# **City of Hyattsville**

# Memo

- To: Mayor and City Council
- From: Jim Chandler, Assistant City Administrator and Director, Community & Economic Development Kate Powers, City Planner
- Date: December 28, 2020
- Re: Federalist Pig Restaurant Detailed Site Plan (DSP-19072) Discussion

Figure 4. Southwest View of Site

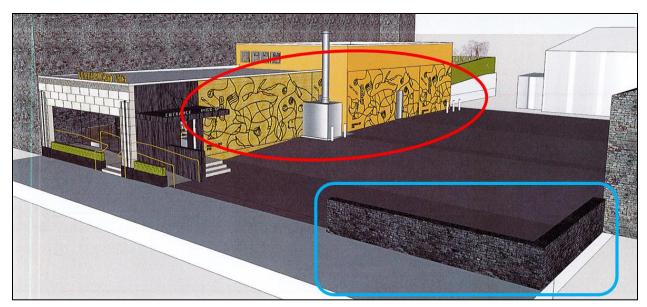
The applicant is proposing a painted mural along the north side of the building which will contain no advertising. The yellow mural depicted in the application is a placeholder and does not represent the finalized design. During the Council's December 21 meeting, Mayor Hollingsworth expressed her desire for the consideration of Black artists for the creation of the finalized mural, as well as an effort by the applicant to hire local, Hyattsville residents.

Both the location of the mural and concrete block wall can be seen in Figure 4. The mural location is circled in red, and the black wall is circled in blue.

- Loading facilities accessed from US 1 (as opposed to a rear alley).
- Communication to the Applicant
  - Staff recommends the applicant consider a local artists for the creation of the finalized mural on the north wall of the building.

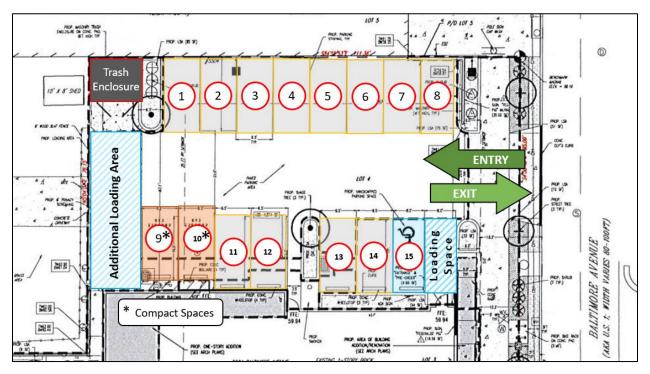
The Applicant plans to retain the existing driveway entrance on US 1 to access the parking lot. This singular vehicle entrance/exit is depicted by the green arrows in Figure 6 (below). The applicant is proposing the inclusion of 15 parking spaces (12 regular/2 compact/1 handicapped) and 1 loading space, labeled in the figure below. In the figure, the regular spaces are gray, the compact spaces are orange, the handicap space is blue, and the loading space is striped.

- Conditions for approval by the M-NCPPC Planning Board
  - Staff recommends that, as a condition for support of the applicant's request for a departure from the parking standards, the applicant provide a parking reduction mitigation strategy for employees and patrons. The mitigation may include, but is not limited to, securing off-site parking facilities, employee incentives for public transit or bikeshare, and bicycle rack installation.

- The applicant's mitigation strategy shall be submitted to the M-NCPPC Planning Board for review by County Transportation staff.
  - Staff recommends the City Council support the following departures from design standards, as proposed by the applicant:
